**From:** Scott Pacheco, AICP  
Hamburg Township  
Planning

**Date:** November 16, 2022

**Project address and Description:** **Final Site Plan (SPA 22-003):** Public Meeting to consider the change in use from a residential use to a commercial use at 7878 M-36. This change will also include the conversion of the existing residential home on the site into a commercial facility with a 1,391 square foot showroom and 961 square foot of office space. The project also will include the addition of a new 5,000 square foot pole barn to the rear of the existing structure for storage of products sold from the site.

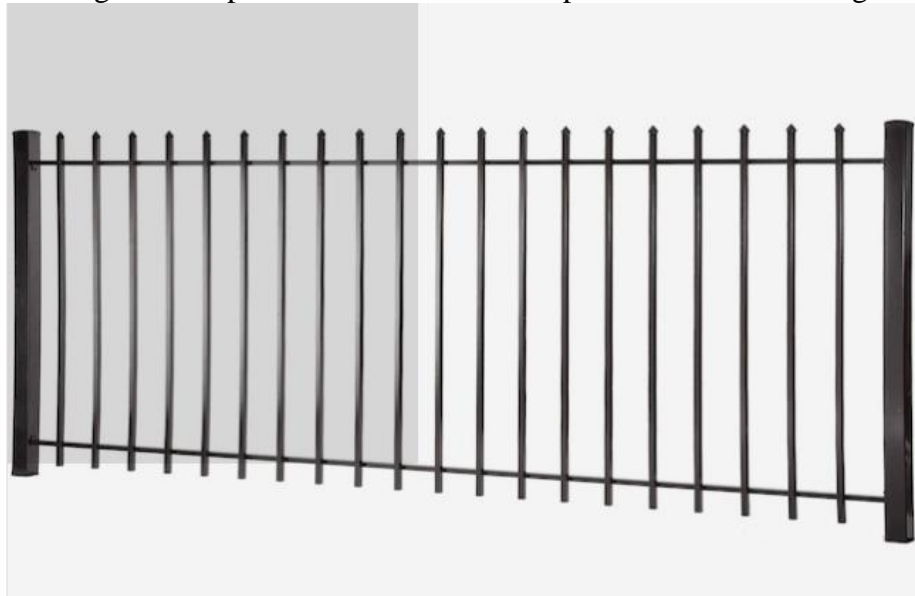
The proposed development will convert an existing single-family home into a commercial use. The existing home is set back over 80 feet from M-36. The proposed project will include landscaping to better screening the property from M-36, an 8-foot-wide multi-use trail that will tie into the existing 8-foot-wide multi use trail on the property to the east and will eventually tie into trails to the west, and proposes paving the existing gravel drive and a new small parking area at the front of the site. The existing garage door facing m-36 will be removed and a glass store front for the carpet store use will be created in this location.

Because of the current design of the drainage basin a 4 foot tall chain link fence is proposed at the perimeter of the drainage basin. Because the drainage basin is to the front of the property between the structures and the front property line, the fence will be visible from M-36.

The applicant shall work with the township engineer to reduce the slope of the drainage basin so no fence is required. If the drainage can not be revised and a fence is required the fencing use shall be decorative and approved by the Zoning Administrator prior to permitting. See the picture below for an example of decorative fencing.
